## **RESPONSE TO OFFICE ACTION**

APPLICANTS: Theodore R. Schlenker; SERIAL NO.: 09/817,368; FILED: March 21, 2001  
EXAMINER: Lam, Thanh; ART UNIT: 2834; ATTY DOCKET: BV3-109476-001

FIG. 5

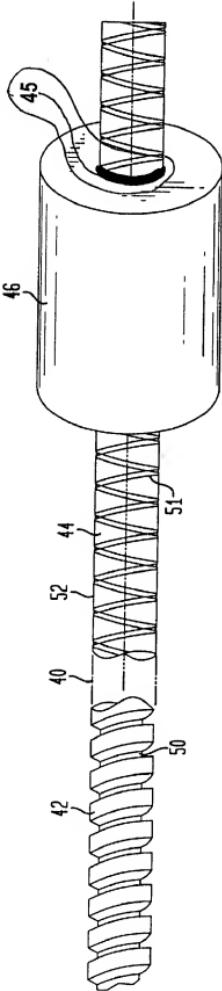
The drawings are deemed by the Examiner to be objectionable under 37 C.F.R. § 1.83(a). The Examiner states that the drawings must show every feature of the invention specified in the claims. Therefore, the Examiner considers that the "permanent magnet" and "an adhesive" must be shown or the feature(s) canceled from the claim(s). The Examiner cautions that no new matter should be entered.

The Examiner states that a proposed drawing correction or corrected drawings are required in reply to the Office action to avoid abandonment of the application, and that the objection to the drawings will not be held in abeyance.

With respect to the "permanent magnet" identified by the Examiner, it is respectfully asserted that this element of structure is adequately represented in the drawing and specification. In this regard, the Examiner's attention is respectfully directed to Fig. 5, element 46, which is described in the specification at page 7, lines 20 to 23, as follows: *Fig. 5 is an isometric presentation of a motor shaft 40 constructed in accordance with the invention showing a working surface region 42 and a*

With respect to "an adhesive," Applicant has amended Fig. 5 to illustrate an adhesive schematically. This does not constitute new matter, as the adhesive element has been present in the specification and claims since the time the case was filed. In this regard, please see the specification, for example, at page 1, lines 12-13, 17-19, and 23-24; page 2, lines 2 and 6; page 4, line 1, 7-8, and 9-10; page 5, lines 6-8; page 8, lines 7-9 and 13-15; and claims 7-10.

Applicant has amended the specification to make reference to the amendment to the drawing. This amendment to the specification does not add any new matter to the case for the reasons set forth hereinabove.

Fig. 5 is an isometric presentation of a motor shaft 40 constructed in accordance with the invention showing a working surface region 42 and a rotor surface region 44, there being additionally shown a permanent magnet rotor 46 that has been adhered to rotor surface region 44 by an adhesive 45. Working surface region 42 is shown in this specific illustrative embodiment of the invention to have a continuous helical groove 50 that is formed of multiple cutting passes using a cutter device, such as cutter tool 35 shown in Fig. 4. In the practice of a method aspect of
